Plan Change 92 Ōmokoroa and Te Puke Enabling Housing Supply and Other Supporting Matters

Copy of Submissions Volume 4

CIUSERSIMINIERACIMIN GEOSCIENCES PTV LTD/CMW CONNECT - TGAI2018/TGA2018-0244 41 QUEEN STREET, TE PUKE QUEEN PALMS LTD/07 DRAMINGS/TGA2018-0244 DW03 ASBULT CONTOUR PLAN REV A 250420 DW0  $\land$

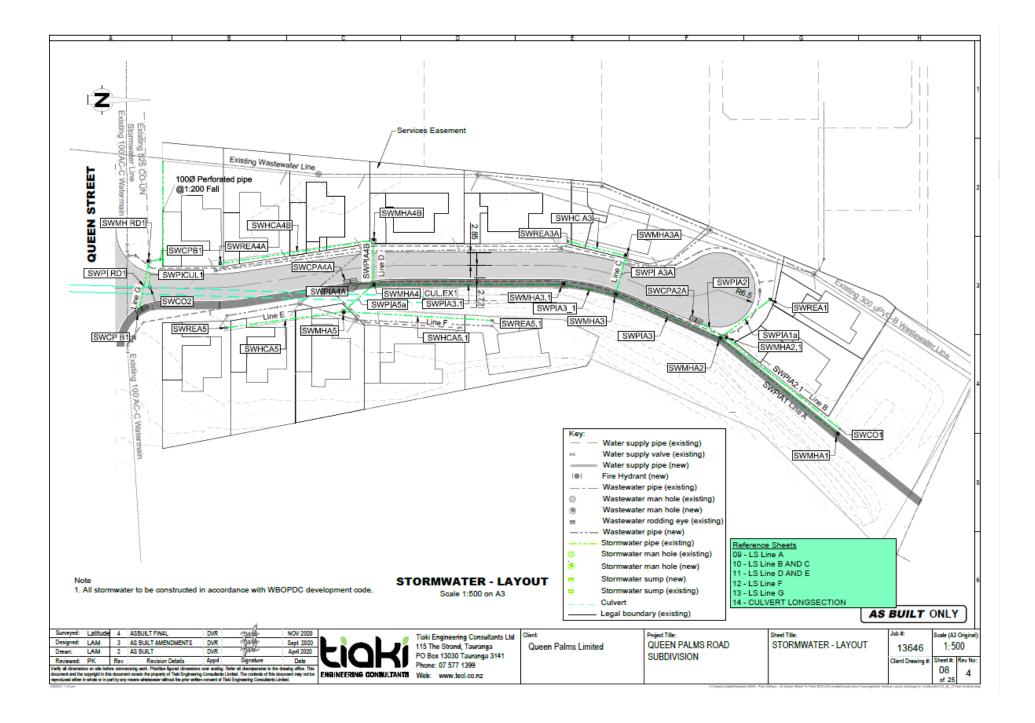
According to the new flood maps, 12 Queen Palms Road appears to be at risk of inundation under the modelling that has been used to determine the extent of a 100-year flood event. From my reading of the maps, it appears that there is little change to the flood model for the Queen Palms development between previous maps and the newly revised map.

During the course of our house build, we received notification that our property was potentially going to be subject to Section 73. This alarmed us as we were under the impression that all required flooding mitigations had taken place in order to obtain resource consent. Further investigation and discussion with the WBDC resulted in our receiving an email from Mr. Nigel Mogford, citing the aforementioned geotechnical report, which outlined that the flooding risk **had** been mitigated, and the imposition of Section 73 was unnecessary. Based on this report and our experience with the Section 73 situation, it came as a surprise43.1to discover that the flood mitigation and changed storm water arrangements of the 41Queen Street development appear not to have been reflected in the new flooding maps.

_ow path	CAD FILE <b>AW_10_LENIHAN</b>	DATE 15	-09-20
	original scale a3 1:200	CT No. -	
	REF. No.		ISSUE
	DWG. No. 10-LENI	HAN	1

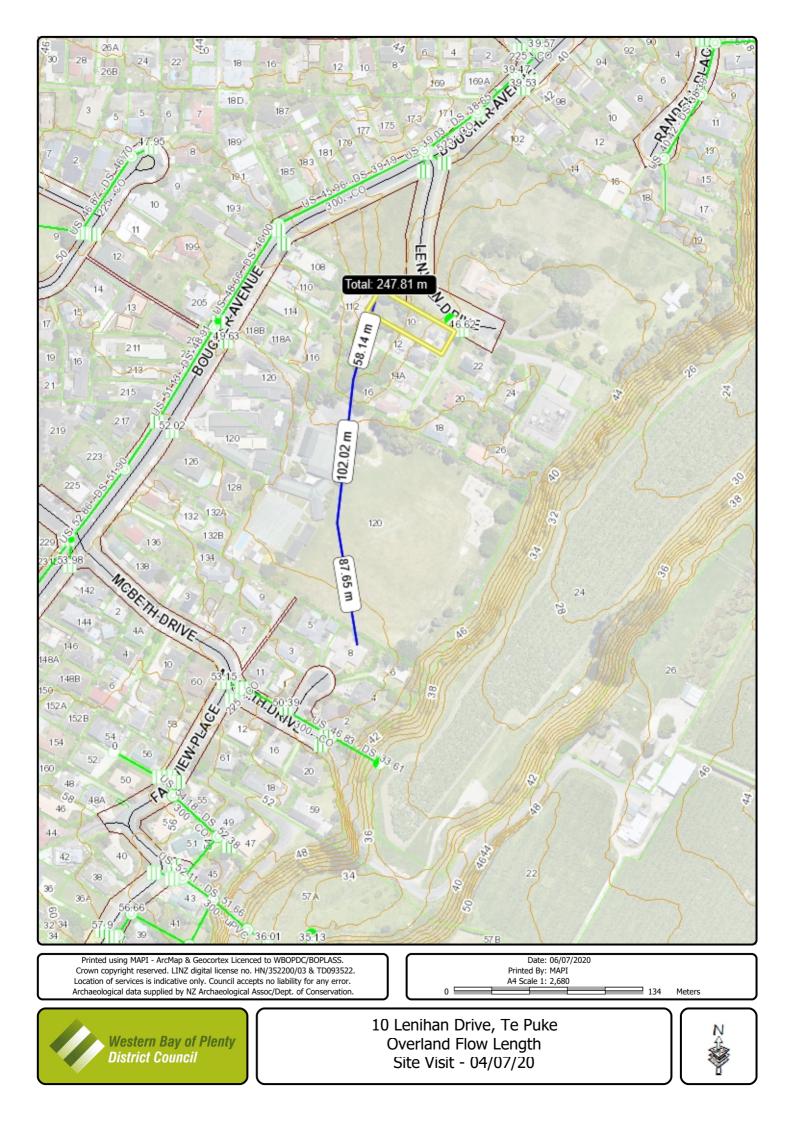
We wish to appeal against the proposed changes shown on the map which show most of which is now Lot 2 as being flooded. As part of the subdivision process with Western Bay Council (which was approved in July last year) we obtained a report from a civil engineer hydrologist (see attached) which showed that only a minimal area of Lot 2 could be affected by flooding.

The proposal is to fill a 35m<sup>2</sup> area 200mm deep within Lot 2 to contain all upstream runoff within a 15m proposed easement area. The attached plan shows the easement and the required fill RL's along the extent of the easement to contain the OLFP within the easement.

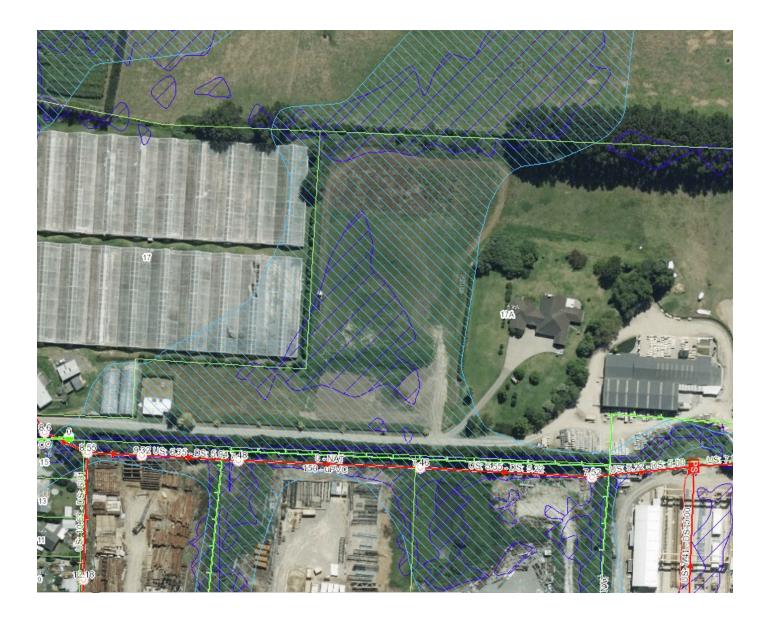
The issue for me is that the grassy area by the glass houses, as proposed as a flood plain by the dark blue lines, is at the same hight as the area on my property not included as a flood plan. Also the area on the northern boundary under the trees is shown as a flood plain, this area is about three meters above the level of the stream and there in no potential to flood in the way that the map currently suggests.

A further consideration. The council has in the past granted a building permit for a building on that ground adjacent to the drain on the northern boundary currently shown as above the flood plain. An engineer also made a solid argument that it was indeed well above the flood plain.

On the eastern boundary the map indicates with dark blue lines that this is also a flood plain. But again, the typography doesn't allow the property to flood in the way indicated.

Can you please reconsider the classification of this area.

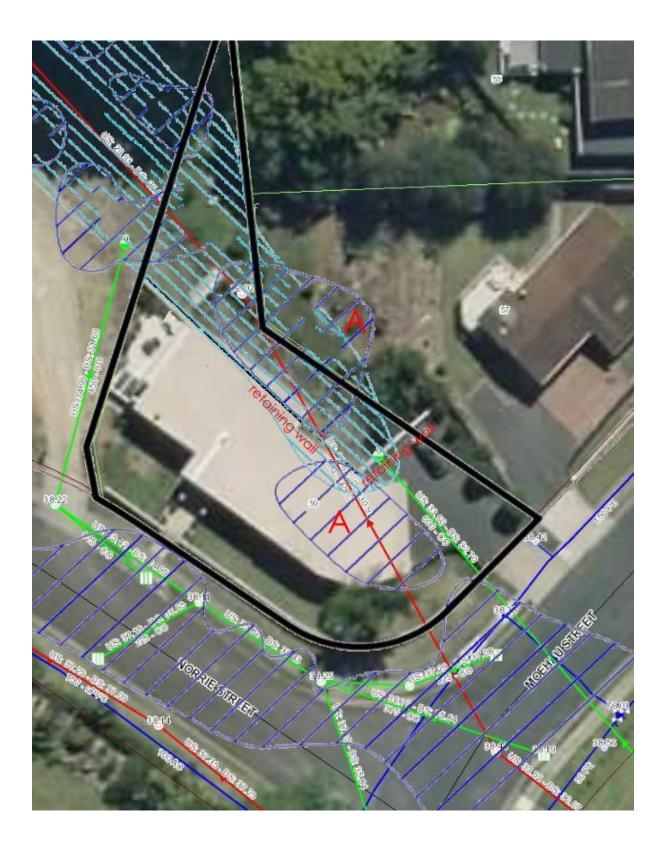
You do not state a stipulated flood level for these new proposed events. The new proposal now includes an area the dwelling occupies, along with areas on the adjacent streets, Norrie Street and Moehau Street.

The new areas appear to be randomly applied to already established sites.

I request a review of this proposal as it impacts the already established area, potentially putting the existing dwelling at risk, negatively impacting future insurance cover for the existing dwelling, and negatively impacting future resale value of the property.

Rather than being reliant on a computer-generated model, I require a qualified Council Representative visit the property to establish areas that have the potential for flooding. Your modelling does not appear to consider the development already undertaken on the site.
